From: Santosh Tambe
Sent: 09 May 2024 18:47
To: Trupti Dalvi; Stephen P; Sarvesh Patil K-Corp
Cc: Chetan Bobade; Sitaram Mistry
Subject: FW: AHMD_FOOD COURT OUTLETS_DHABA
Attachments: AHM Wow Momo & Wow China - BOQ.xlsx

Subject: **FW: AHMD_FOOD COURT OUTLETS_DHABA**

Subject: AHMD_FOOD COURT OUTLETS RENDER

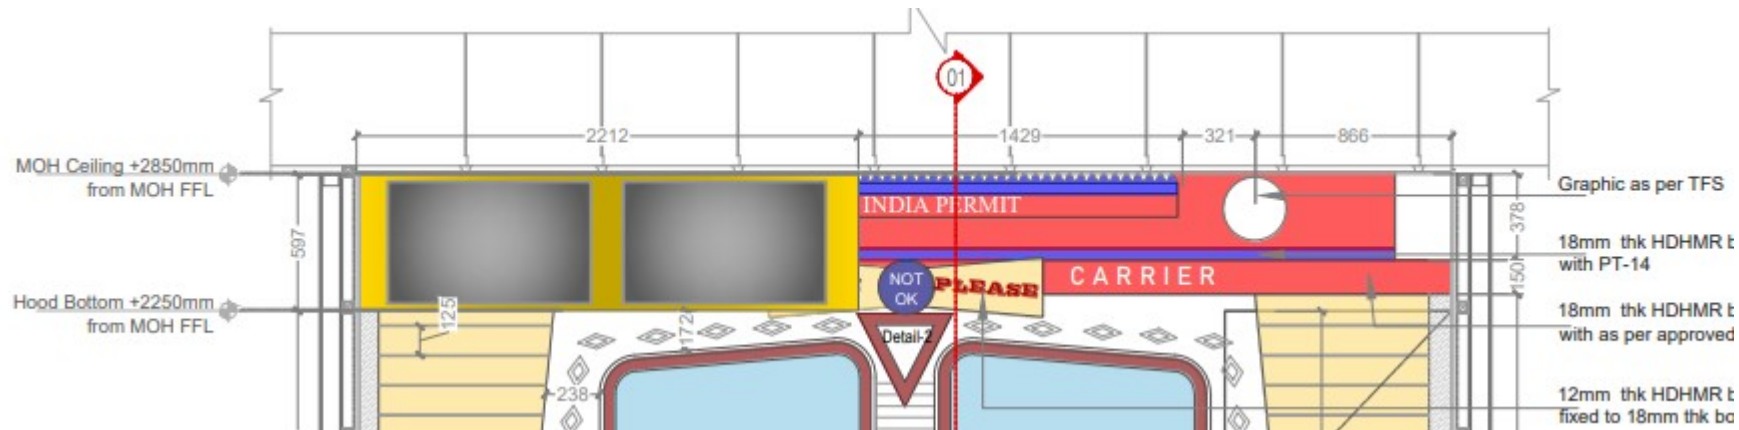
please share dimension of the graphic letters "INDIAN PERMIT" and "CARRIER" at Dhaba outlet at Ahmedabad Food court T1

Please find the attached text height as required.
